# ADDENDUM NO. 03 WASHINGTON COUNTY RECORDS STORAGE

## **BRENHAM, TEXAS**

# RENOVATIONS TO WASHINGTON COUNTY RECORDS STORAGE

HEET NO.	P1.01
HECKED BY	СКТ
RAWN BY	ZDS
SSUE	BID SET
ROJECT NO.	2408PN

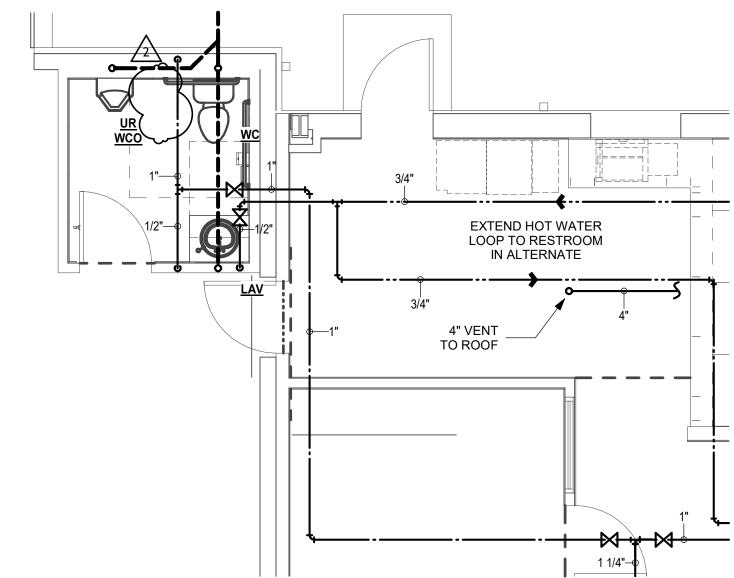
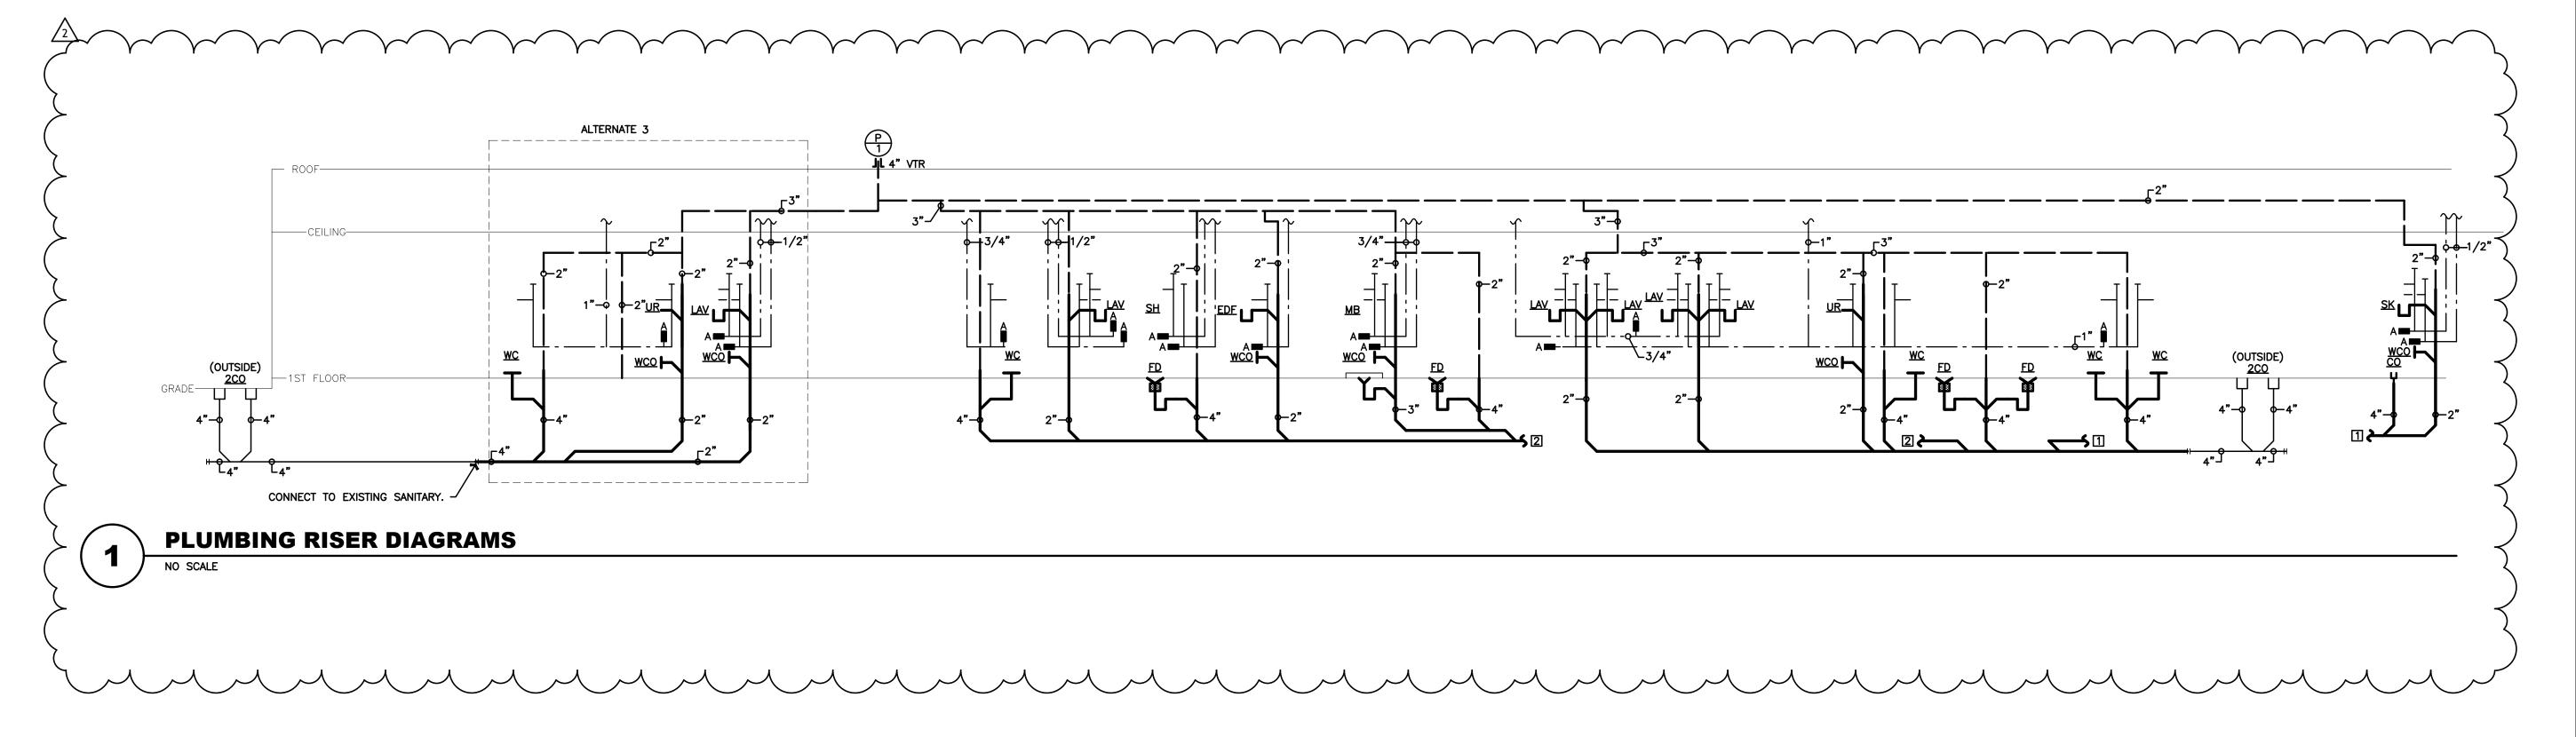
- Question: On sheet P1.01 it is currently showing for the new sanitary to connect North of Alternate #2 RR 122. The existing toilet is a backflush and at the cleanout it is only 8" BFF. There will not be enough elevation to slope all the fixtures including break room 116. Also, we have not been able to determine if the existing facility is on a septic system for sanitary since no manholes are site sanitary line is shown on the drawing and if the domestic water is on a well since no water meters have been located.

- A. Sheet P1.01 Plumbing New Floor Plan
  - Revised to reroute most of sanitary to different existing outlet. Removed floor drain in single restroom due to depth. Removed floor sink for water heater and will drain to mop basin due to unknown depth.
- B. Sheet P2.03 Plumbing Schedules & Details01 Update to sanitary sewer diagram.

- a. Answer: Sheet P1.01 revised to reroute most of sanitary to different existing outlet. Removed floor drain in single restroom due to depth. Removed floor sink for water heater and will drain to mop basin due to unknown depth.
